CULVER

SALIX COTTAGE

● TREES TO CUT

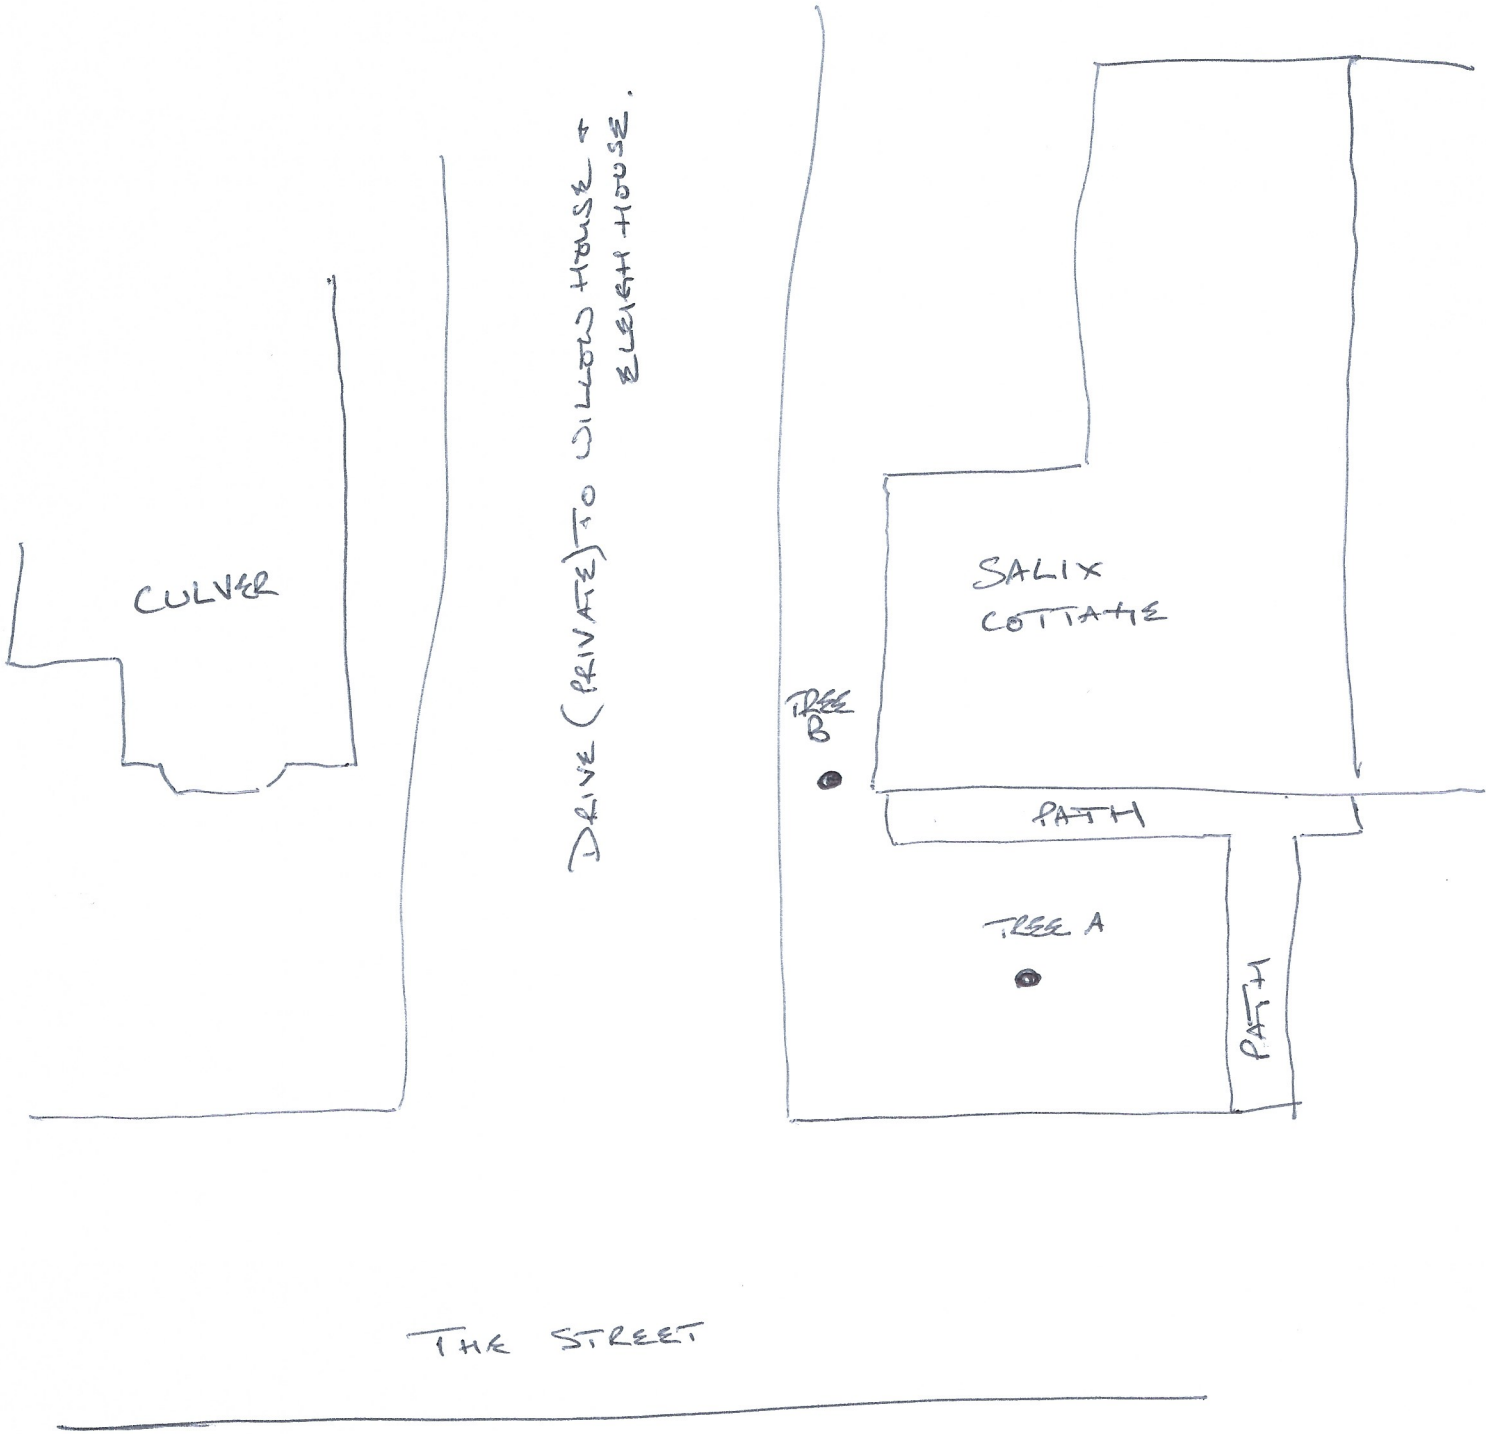
TREE A: NEEDS RESHAPING AS IT IS BRANCHING TOO CLOSE TO WINDOWS. PROXIMITY TO HOUSE ACCEPTED BY INSURERS, BUT ONLY JUST!

TREE B: MUST BE REMOVED AS IT IS JUST A FOOT FROM FOUNDATIONS AND WALLS. SUBSIDENCE RISK AND NOT 'INSURANCE' COMPLIANT.
